CITY OF PORTLAND

BUILDING PERMIT

Job ID: 2012-03-3565-ALTR

has permission for an addition of new steps (Single Family Residence).

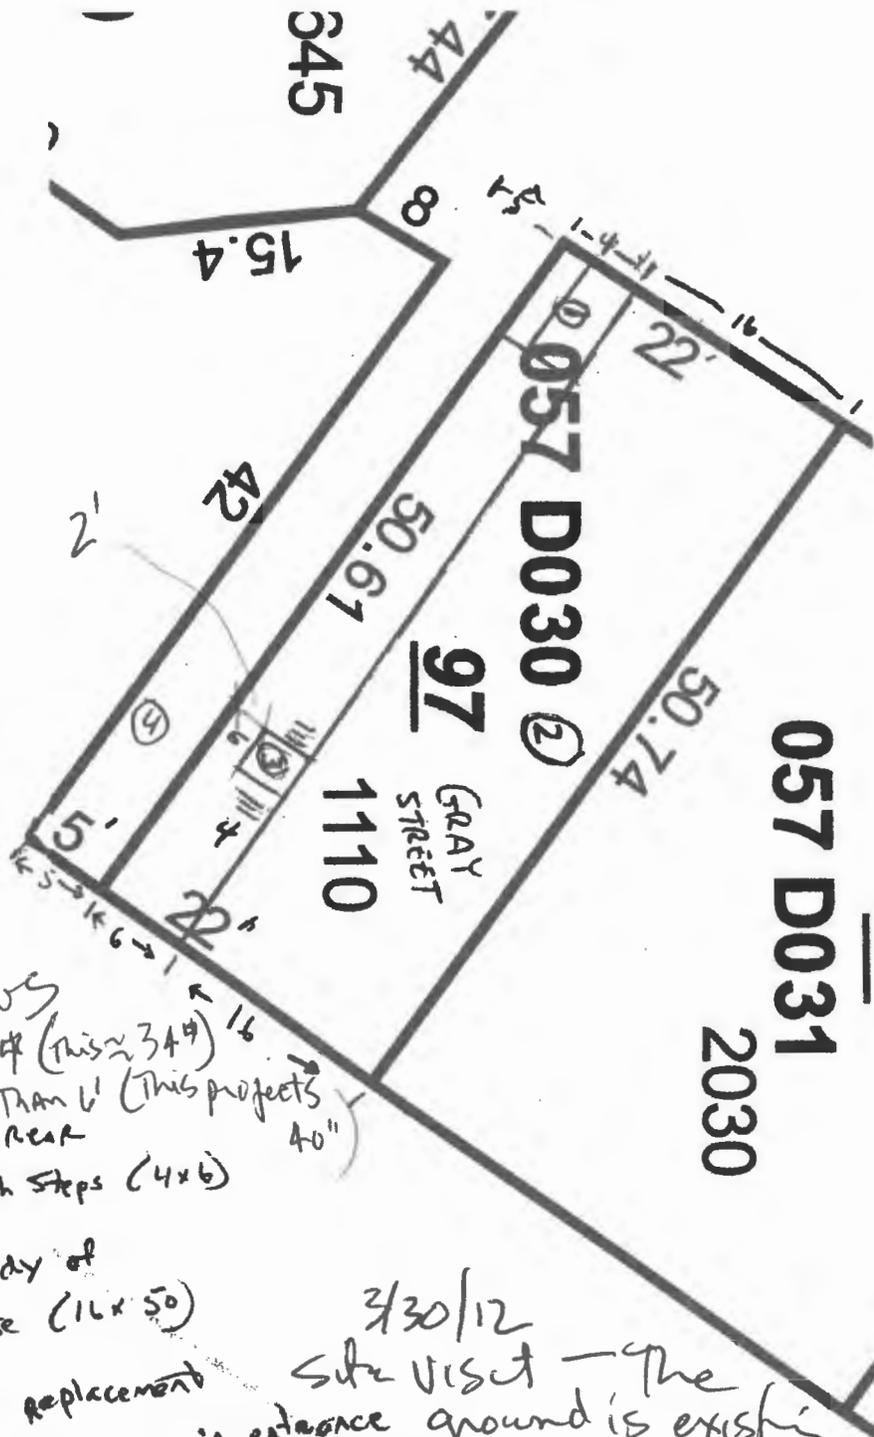
14-425 allows
 no less than 50" (this is 34")
 and project no less than 6" (this projects
 40")
 Existing rear
 entry with steps (4x6)

3/30/12
 Site visit - the ground is existing
 There is an existing door that was not recently put in - *[Signature]*
